## REVISED RESPONSE TO REQUEST FOR ADDITIONAL INFORMATION

### APR1400 Design Certification

Docket No. 52-046

RAI No.: 368-8470  
SRP Section: 14.03.08 – Radiation Protection Inspections, Tests, Analyses, and Acceptance Criteria  
Application Section: Tier 1  
Date of RAI Issue: 01/19/2016

Figure 1 Discrete and Cumulative Frequency of MCR Damper Re-opening Interval Time using Korean Meteorological Data

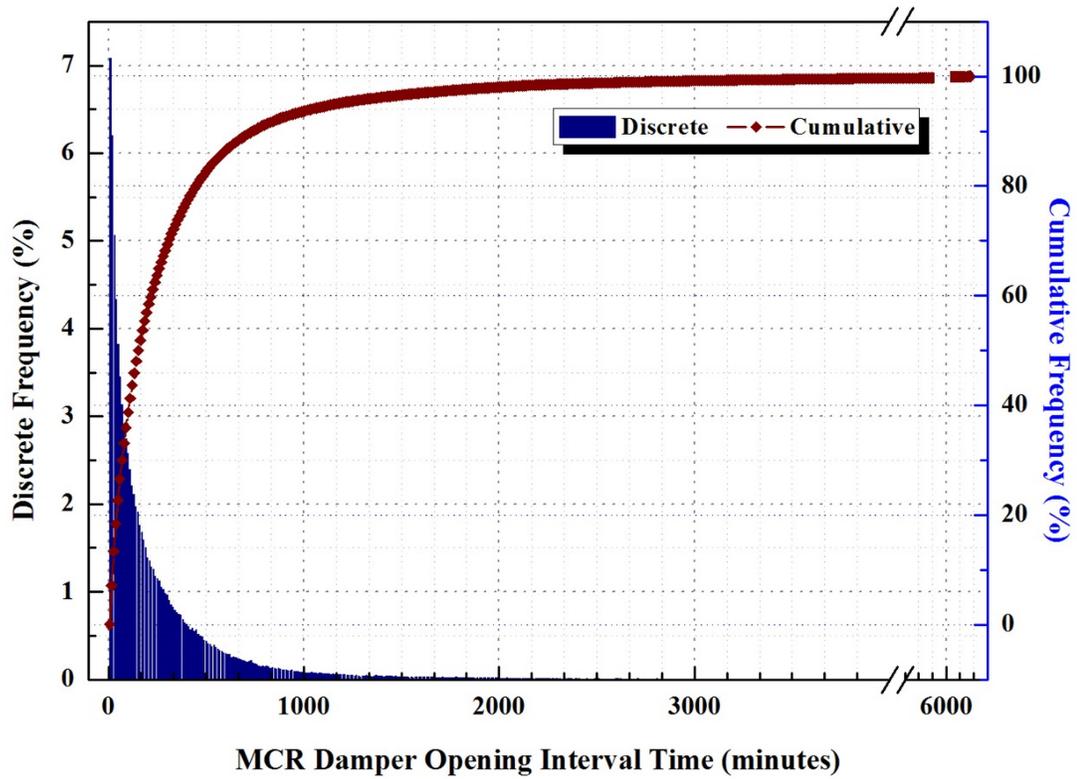
- b. ITAAC 9 in Table 2.7.3.1-3 indicates that upon detection of radiation in the outside air intakes, the air intake isolation dampers in the air intake having the higher radiation level close automatically. When one air intake is closed, the radiation readings on the associated radiation monitor will likely greatly decrease because there is no longer air being drawn in the intake. During an accident, please indicate if the intake that initially has the higher radiation is closed and will remain closed regardless of radiation levels, or if the closed intake will automatically open if higher radiation levels are detected in the open intake. If the design is such that the open intake could continually change automatically based on radiation levels, please discuss why this design is appropriate.

The onsite  $\chi/Q$ s were calculated using the ARCON 96 code; where the length of the averaging period is approximately 1 hour. Therefore, the interval time of 1 hour between opening the closed intake was conservatively determined for evaluating the impact of the damper re-opening. To demonstrate that the interval time of 1 hour used for this evaluation is reasonably conservative, a frequency analysis of time required for the wind direction to change 45 degrees was performed using the Korean 10-minute average meteorological data ('11.07.01 ~ '13.06.30, Ulchin) and UAE 10-minute average meteorological data ('12.04.01 ~ '16.03.31, Abu Dhabi), respectively. The interval time based on the Korean and UAE meteorological data were statistically processed and the statistically representative values at the 5<sup>th</sup> percentile, 95<sup>th</sup> percentile, mean and median (i.e., 50<sup>th</sup> percentiles) were chosen to represent the distribution of frequency of the interval time (refer to Tables 1 and 2, and Figures 1 and 2).

The results of frequency analysis have shown that the interval time of 1 hour used for evaluating the impact of the damper re-opening corresponded to the 30<sup>th</sup> and 13<sup>th</sup> percentiles for Korean and UAE meteorological data, respectively, which means that the probability that the wind direction would change by 45 degrees or more within 1 hour following the initiation of the event is less than 30.0 and 13.4 percent, respectively, during the given period. Though lower percentile values than these could be used to provide a more reliable auto-selection function of
